## TECHNICAL MEMORANDUM

Project No. 21457143

**DATE** January 21, 2022

### ADDENDUM TO THE NOISE IMPACT ASSESSMENT REPORT - PORT COLBORNE QUARRIES INC. PIT 3 EXTENSION

TITLE  
**EXTRACTION PHASE 2- NOISE CONTOURS**

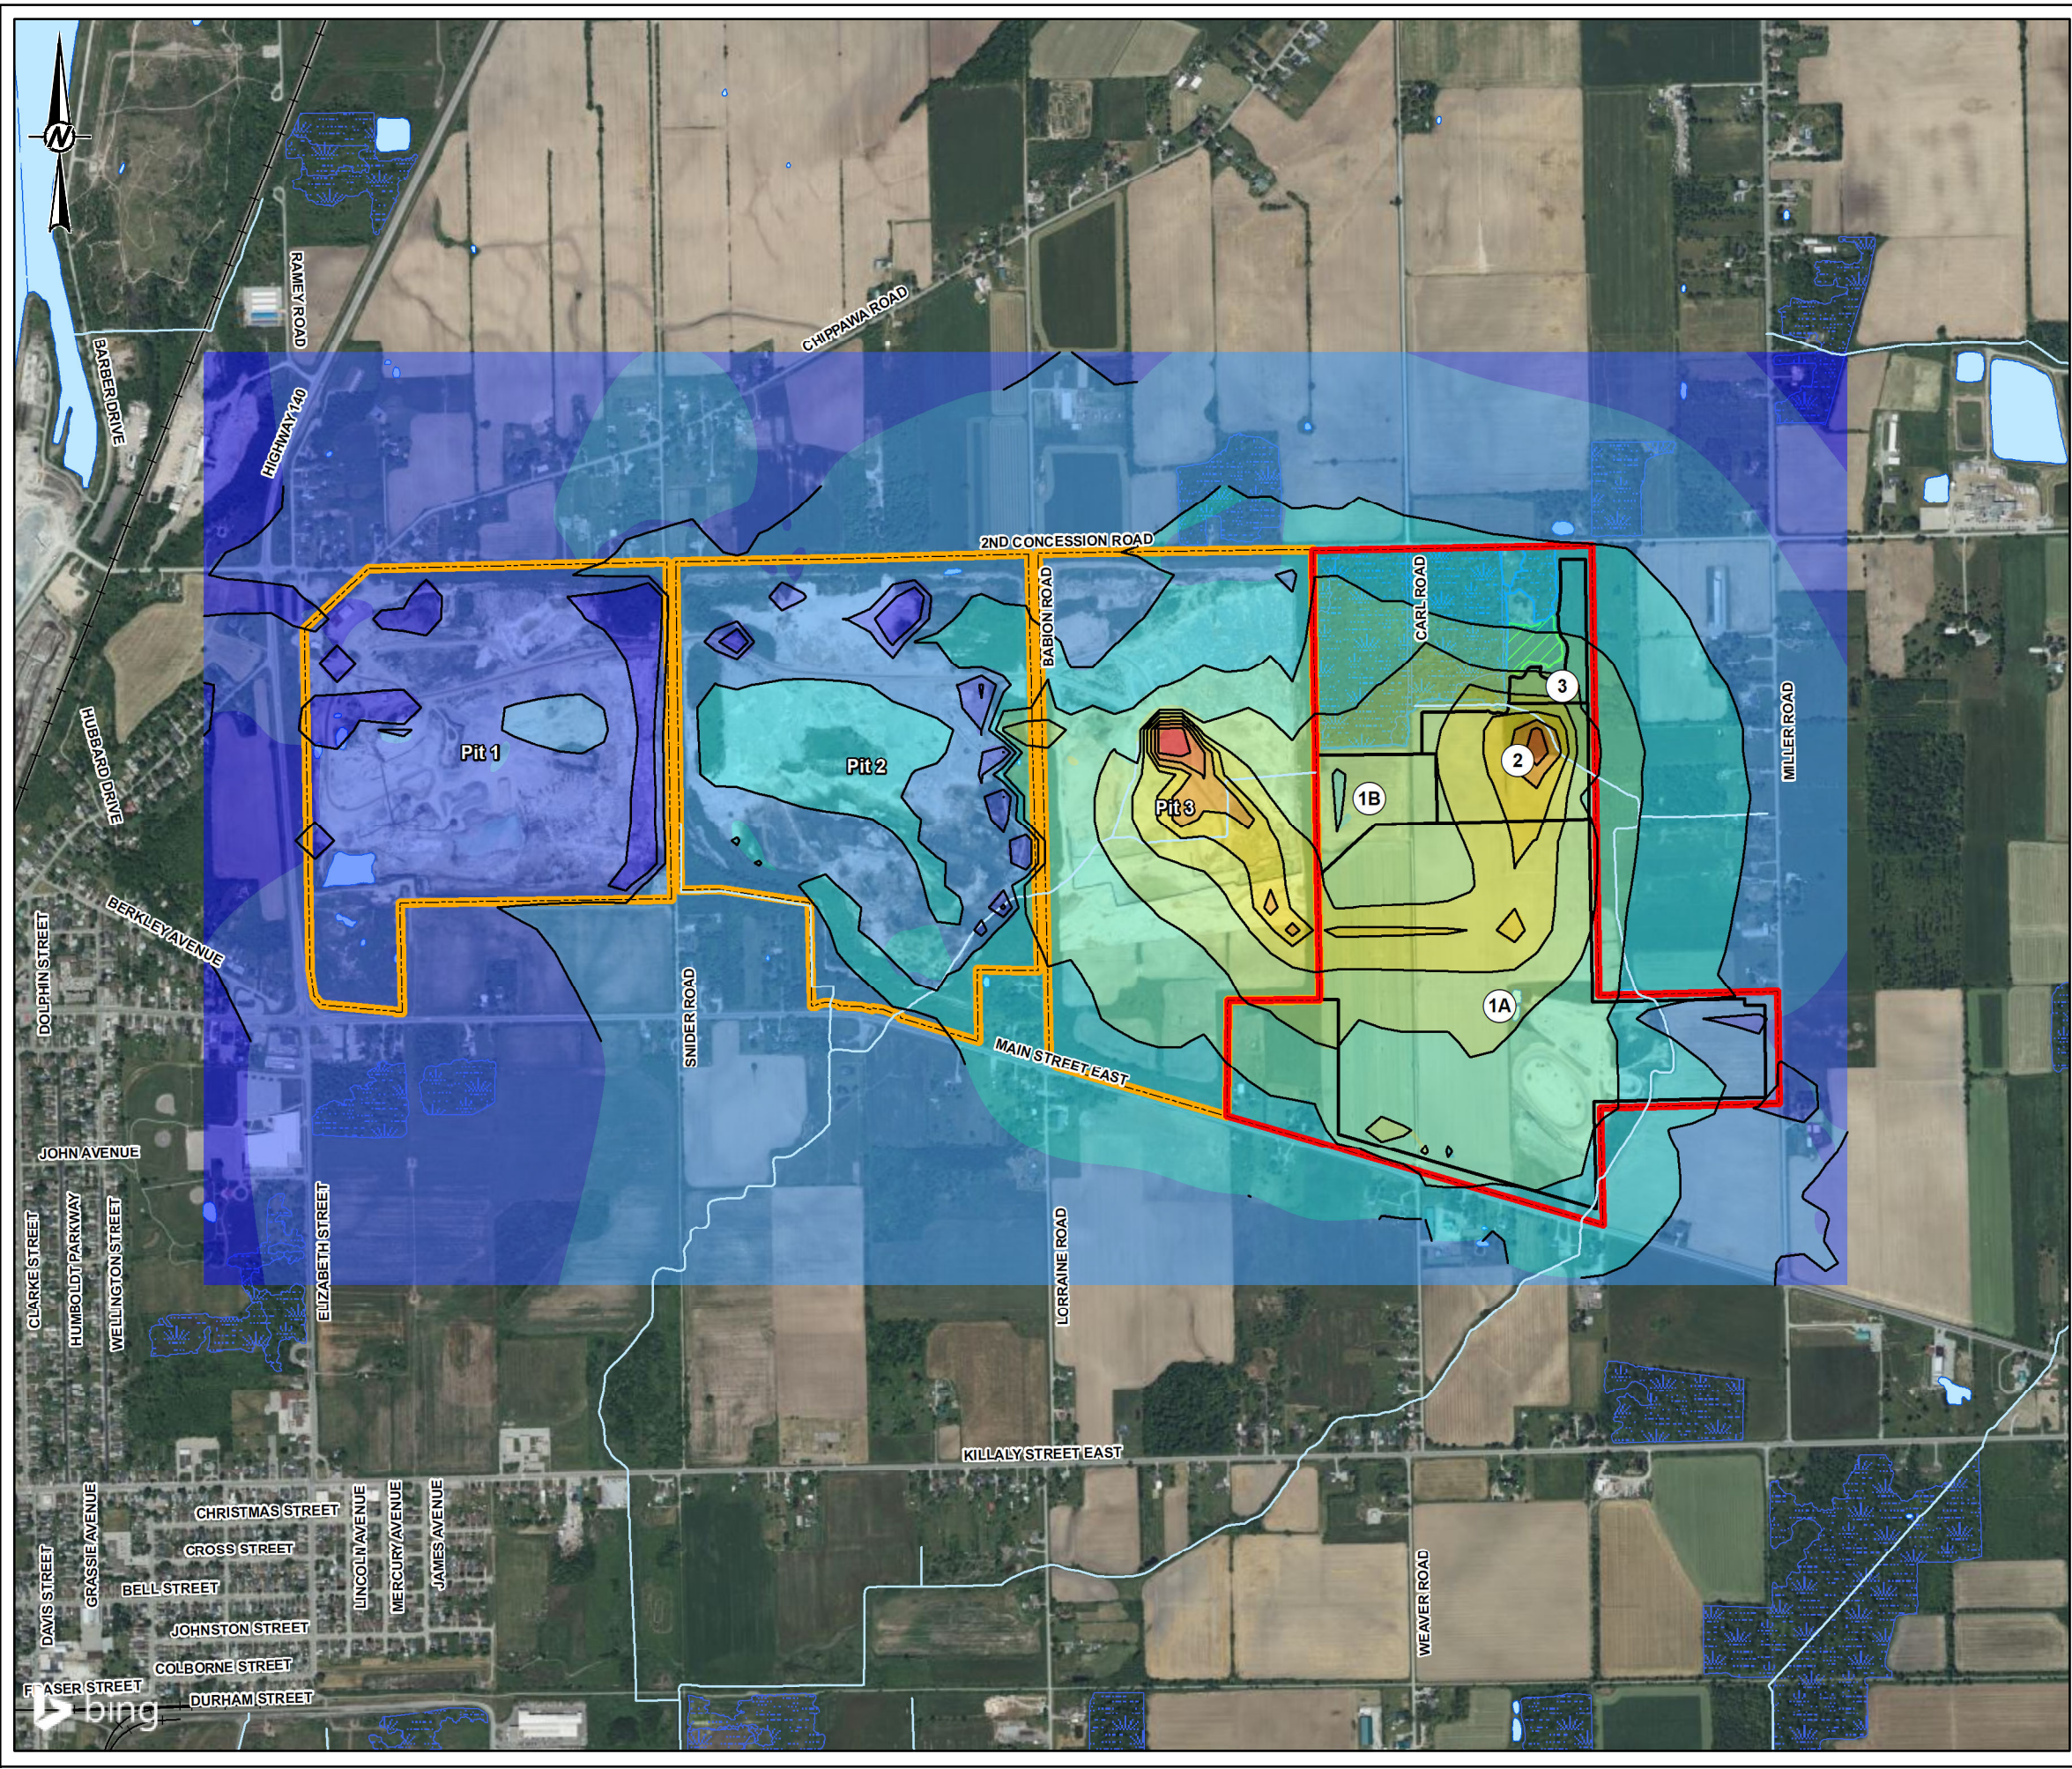
Comment ID	Comment	Location in Addendum
2.d	Page 4 indicates that the processing equipment may be moved to an alternative location in the future. Based on the video summary ( <a href="https://portcolbornequarries.ca/quarry-expansion-document">https://portcolbornequarries.ca/quarry-expansion-document</a> ) of the proposed extension it is understood that this location is planned to be in Pit 3. In this case, the NIA should include an assessment of this scenario, and depending on the results include mitigation measures to achieve compliance.	Section 2 of the addendum presents details of noise impact assessment for operations of the relocated processing plant. Predicted noise levels associated with Phase 2 and Phase 3 operations are presented in Section 2.1.

Table 2 summarizes the noise levels predicted for the operations associated with Phase 2 and Phase 3 with the relocated processing plant and new Site entrance. The associated operational noise contours are shown in Figure 1 and Figure 2.

The results presented in Table 2 indicate that the noise emissions for Phase 2 and Phase 3 comply with applicable criteria. Therefore, the Site is expected to be able to operate in compliance with applicable noise limits.
